Memorandum

Crane Mountain Landfill Capacity Augmentation and Life Extension

From: Kerry Rowe, RKRI

Re: Technical Review of the *Environmental Impact Assessment* for the Proposed *Crane Mountain Landfill Capacity Augmentation and Life Extension Project*.

Figure 1: Detail of the barrier system from the GEMTEC Report¹

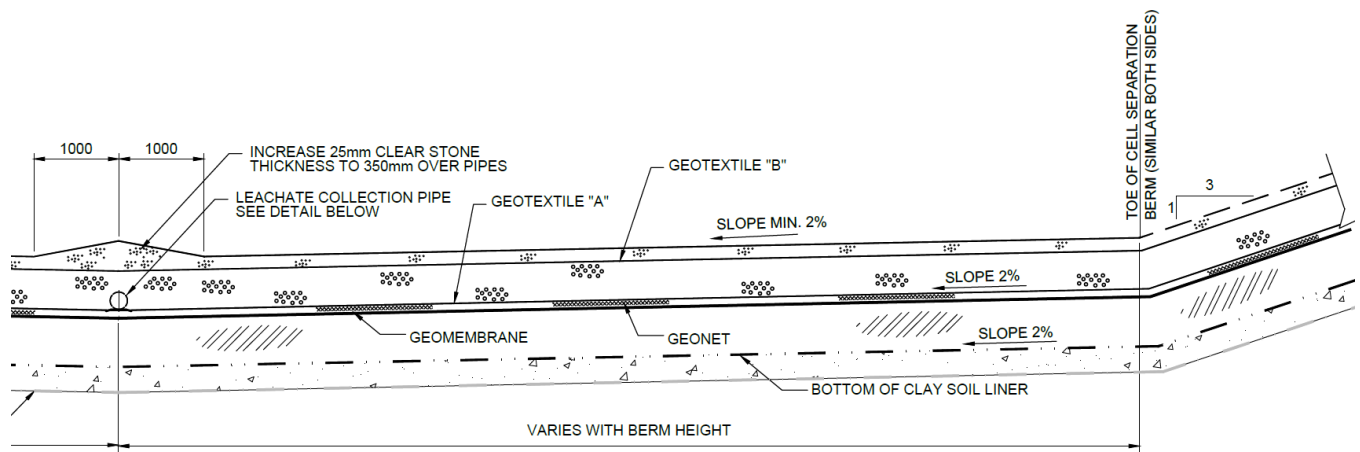
Figure 1 shows the barrier system at the Crane Mountain landfill directly from a GEMTEC report¹. The barrier system is comprised, from top-down, of a leachate collection system (a layer of 25 mm clear stone over geotextile B, over what is presumed to be more gravel, over geotextile A, over a geonet), on

a geomembrane on a clay soil liner. The nature of the material below the soil liner is not defined (it is understood to be a relatively thick in-situ soil in some areas and much less so in others). The bedrock underlying the landfill is fractured.

The technical literature refers to a single geomembrane over compacted clay as a single composite liner system. In this system, the geomembrane provides the primary barrier to downward fluid flow/migration, with the compacted clay intended to reduce leakage through holes in the geomembrane and provide additional protection related to minimizing the potential for advective and diffusive transport through the liner system.

Figure A1: Detail of the barrier system from the Gemtec Report.

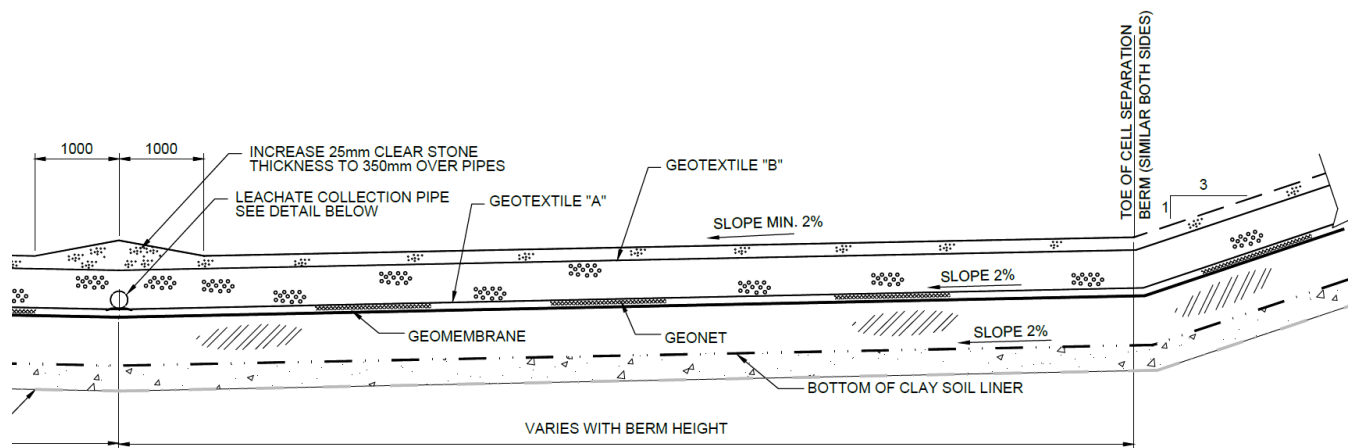
- (viii) The predicted fastest time of for the contaminant to travel to downstream boundaries is 20 to 50 years, and the median time is 200 years.
- (ix) There is a 300 mm granular subbase below the compacted clay liner (Figure A1 below).
